1B AND 1BA TELEPHONE ANSWERING SETS INSTALLATION AND CONNECTIONS

1.001 This addendum replaces Addendum, Issue A and Supplementary Addendum, Issue A. It is reissued to add information on how to increase the recording cycle by 10 seconds. It also retains information from preceding addenda.

Fig. A

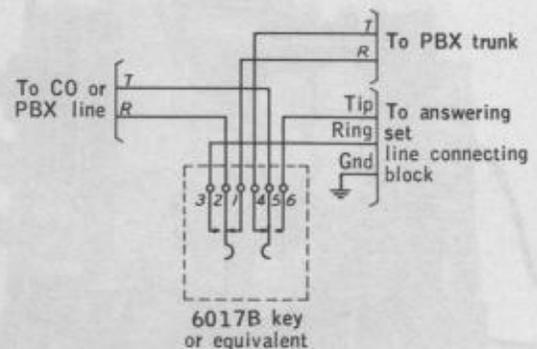
7.05 Should the service order specify the installation of the 1B answering set in connection with PBX trunks, it will be necessary to provide a transfer key and a separate station instrument. The transfer key shall be connected to provide alternate service for either the 1B answering set with its associated telephone, or the PBX trunk jack (See Figure A).

NOTE: When Figure A is used, the answering set must be equipped with a separate telephone set.

Fig. C - P-44C553 - Pulley (Modified for Increasing Recording Cycle)

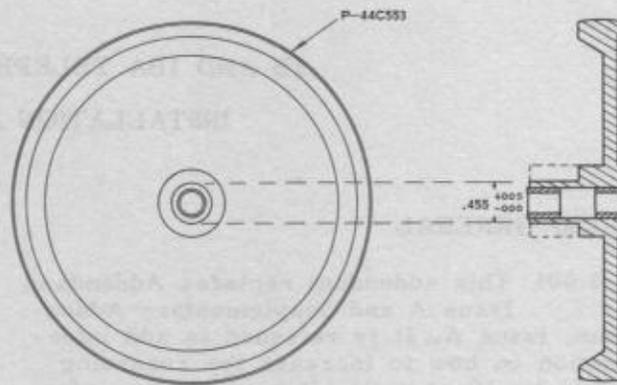
8.003 This is accomplished by using a second stage drive pulley with a smaller diameter hub. And using a shorter drive belt.

Fig. B - Telephone Answering Set - Left Side Pulley Drive Arrangement

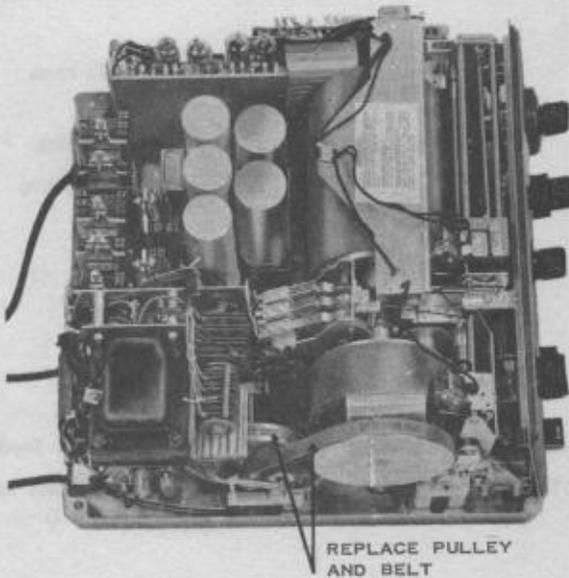
8.002 The increased recording cycle is obtained by rotating the recording drum at a slower rate.

8.004 Figure B shows the location of the pulley and belt, as seen from the left side of the answering set with cover removed.
